Subject: Planning Application 26/0099 - FAW - development of pitch/changing rooms/spectator stands/tv gantry/storage/car parking

Proposal: CONSTRUCTION OF A NEW FULL-SIZE 3G SYNTHETIC SPORTS PITCH, SPECTATOR VIEWING AREAS INCLUDING 2NO 125-SEATER STANDS, TV GANTRY, CHANGING FACILITIES, PARKING AREA, ACCESS IMPROVEMENTS AND ASSOCIATED WORKS

Formal Objection to Planning Application – 26/0099

Figure 1 125 year Lease CYM587716 between NCC and FAW Sports Development Ltd

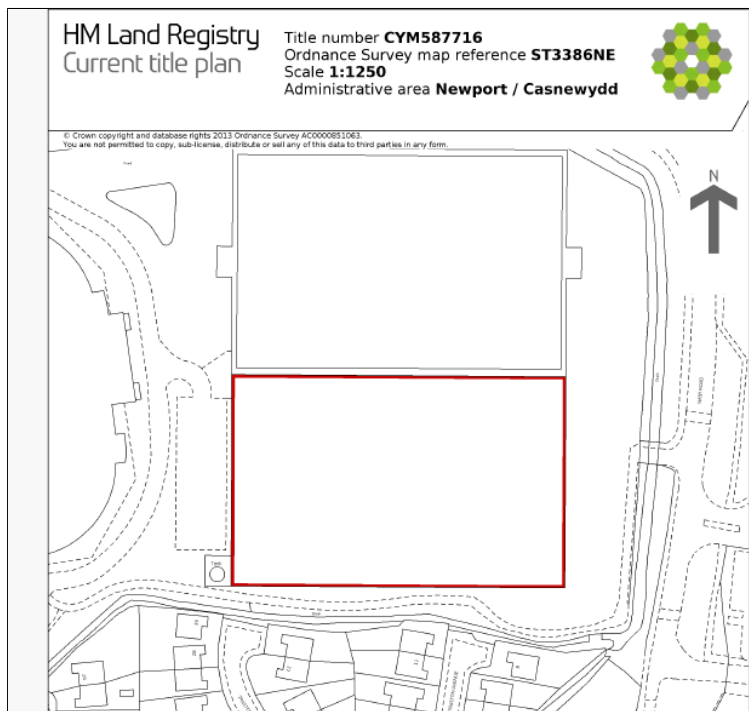
- that the current grass pitch would be replaced with exactly the same size 3G pitch, which is shown on the 125 year lease number CYM587716 shown below in **Figure 1** between Newport City Council and FAW Sports Development Wales Ltd.
- That public would not be allowed to view the pitch used for elite training and therefore it would be enclosed in the same manner as the main pitch at Dragon Parc HQ, which is actually at Spyttý Boulevard, NP19 4RA. (the pitch in the proposal is actually at Velodrome Way NP19 4RB)
- The lease would be extended, by a change to the lease between NCC and Newport Live, which would include:

Figure 3 General drawing dated 02/04/26 showing 5.1 metres from existing to new fence

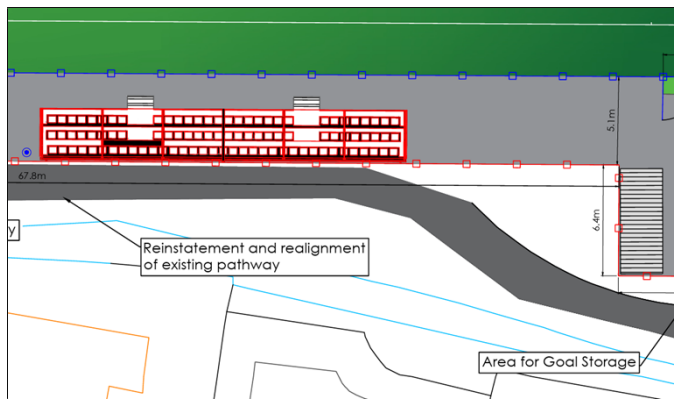
- a) 2 x 125 seater spectator stands
- b) Tv gantry
- c) Pathway in front of stands
- d) Area for a standard container (assume 20 ft long x 8 ft 6" x 8 ft 6")
- e) Floodlights at a height of 15 metres
- f) All enclosed by a 7.5 metre fence
- g) Original general drawing *Figure 3* showed the main length of the fence to be 5.1 metres from the current fence. (informed at the FAW meeting that this is reduced to 4.1 metres, but is not shown on the current general drawing *Figure 4*)

This raises a fundamental question about the accuracy and reliability of the submitted plans. If the seating and fencing distance on the plans submitted have no measurement on them, and there is no record put forward by FAW of the meeting with residents, where it was stated that the width had been reduced from 5.1 metres to 4.1 metres, then the only measurement submitted would take the line of the back of the seating to the other side of the path, closest to the reen.

The measurement on the plan, whether 4.1 or 5.1 metres cannot physically be installed in the position shown, and the plans do not provide an accurate representation of the development for which permission is being sought.
